## Response to Submissions

Building R5, Barangaroo South  
SSD 6966

Submitted to Department of Planning and  
Environment  
On behalf of Lendlease (Millers Point) Pty Ltd

28 November 2018 | 10051

**Figure 5 Modified podium building line**

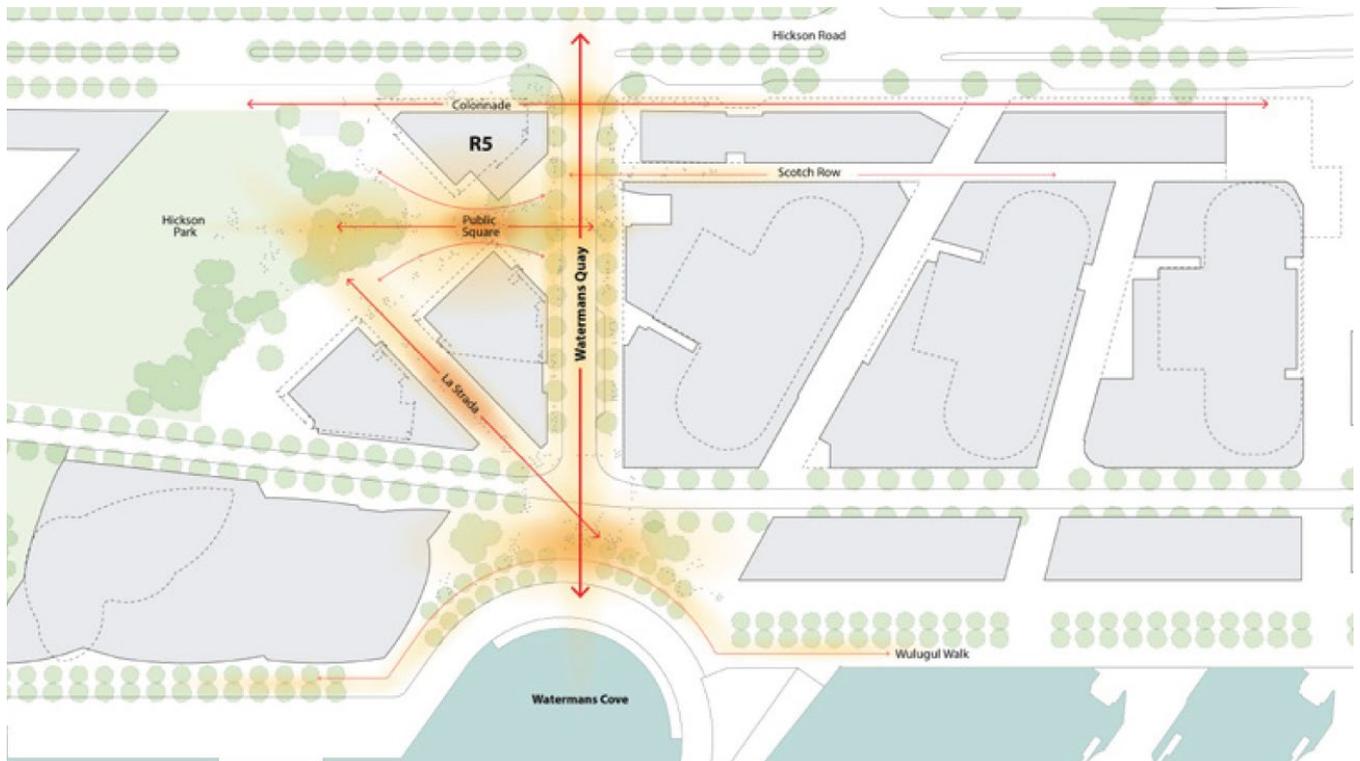
In addition to this, the secondary public route from Scotch Row through to Hickson Park has been improved by realignment of the podium façade, creating a plaza to Watermans Quay and continuity from Scotch Row. This is illustrated at **Figure 5**.

**Figure 9 Building separation between R5 and R4B**

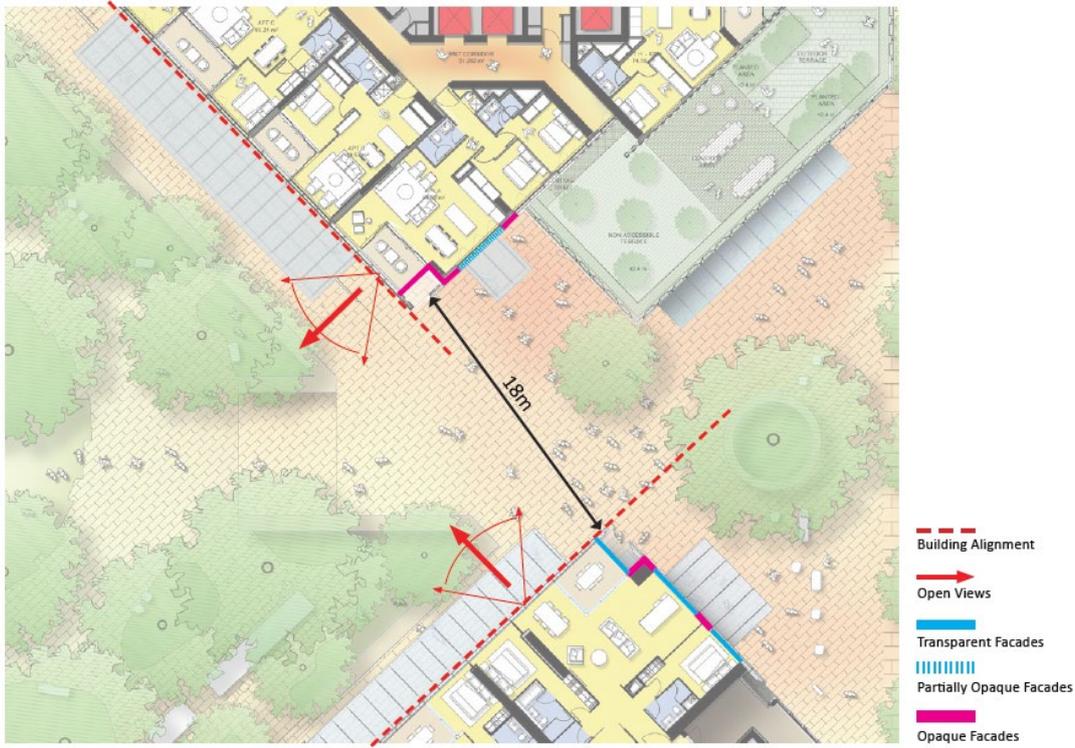
The Supplementary Design Report at **Appendix D** provides detailed diagrams demonstrating the separation between each building and design measures that have been incorporated to maintain visual privacy. **Figure 9** shows the relationship of Building R5 to Building R4B and demonstrates that the recommended building separation is achieved.

The minimum separation distance between Building R5 and Building R4B is 18 metres, which is consistent with the amount required by the Design Guidelines and is therefore consistent with the approved Concept Plan (as modified).

**Figure 14 Revised building height (refer to Architectural Drawings at Appendix D for further detail)**

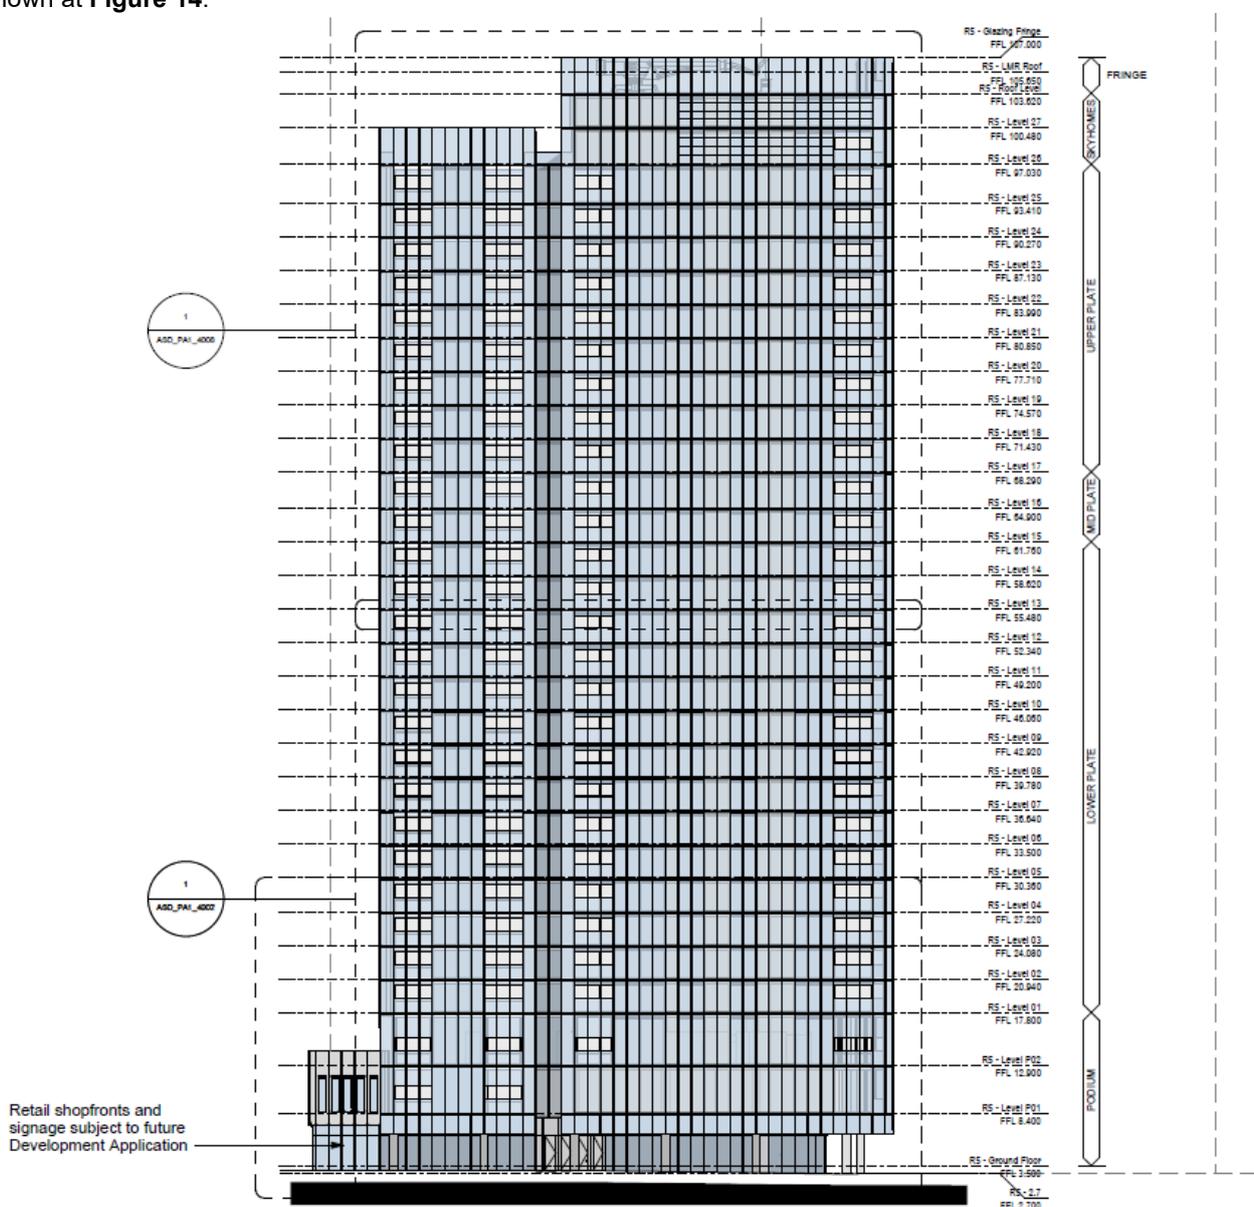
The height of the residential tower has been increased by one storey, from RL101.140 to RL105.65. The architectural roof feature rises to a height of RL 107, consistent with the maximum height of RL107 set under the Concept Plan (MOD 8). This increase in height allows for the accommodation of 3 bedroom, split-level apartments to accommodate families and contribute to a diversity of dwelling types. These dwellings types replace the penthouse that were proposed as part of the exhibited application. An illustration of the revised building height is shown at **Figure 14**.

**Figure 18 Key façade and tower design changes**

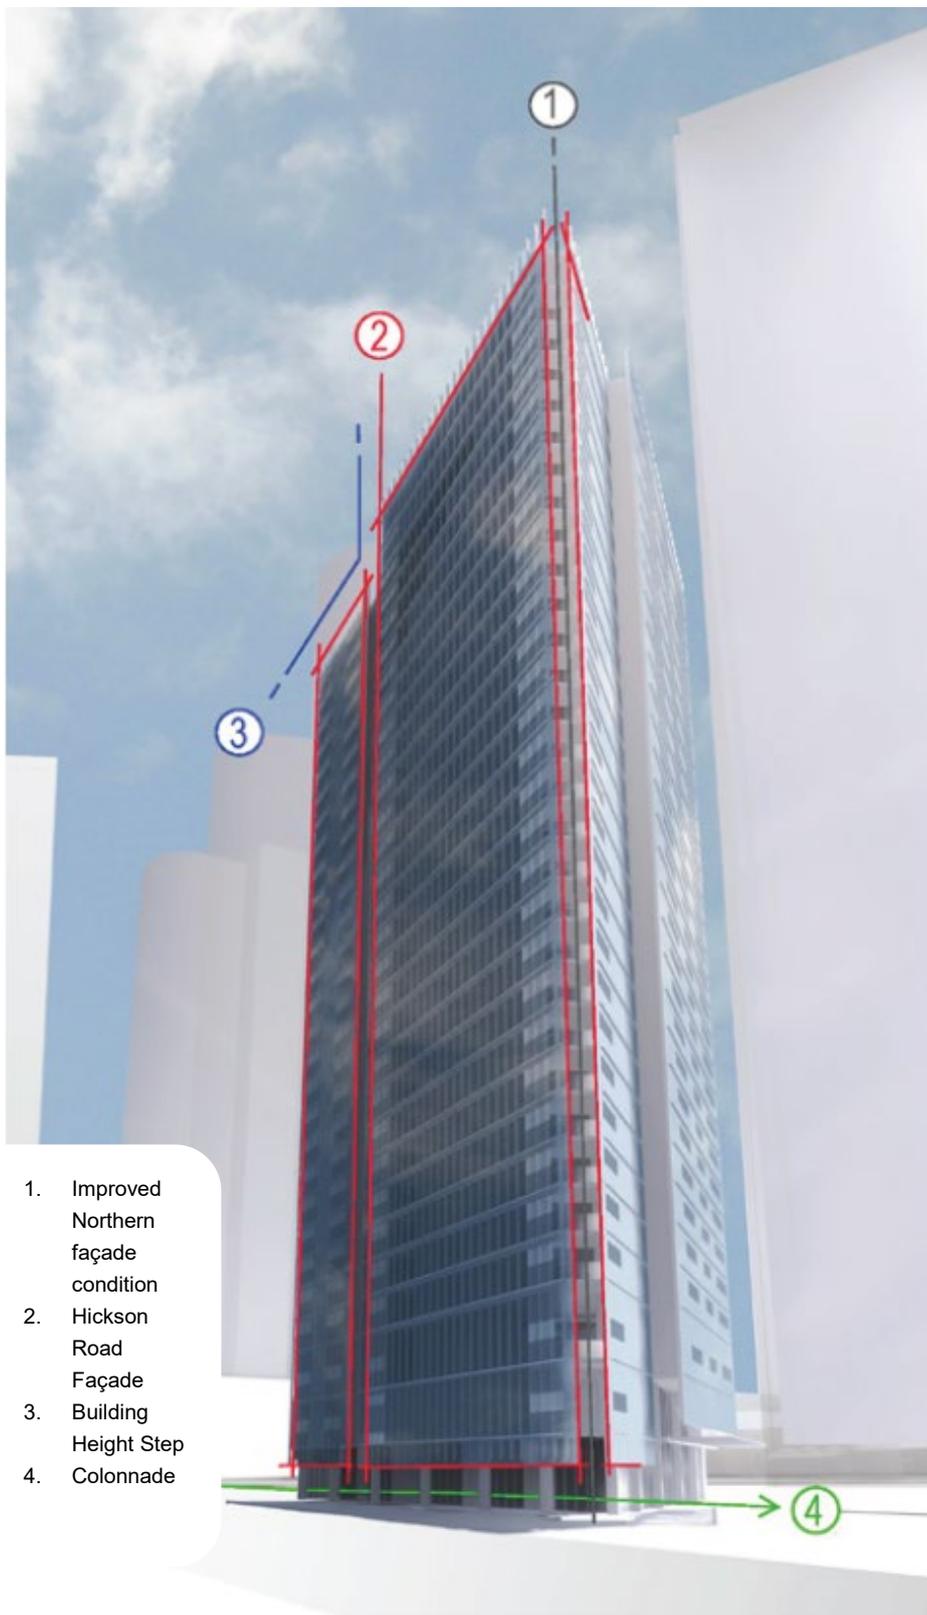
Four key changes have been made to the overall tower design, as illustrated at **Figure 18** and as outlined below.

A ‘notch’ has been incorporated into the Hickson Road façade, as illustrated in **Figure 18**. This notch modulates any perception of building bulk and creates two distinguishable elements to the building form.
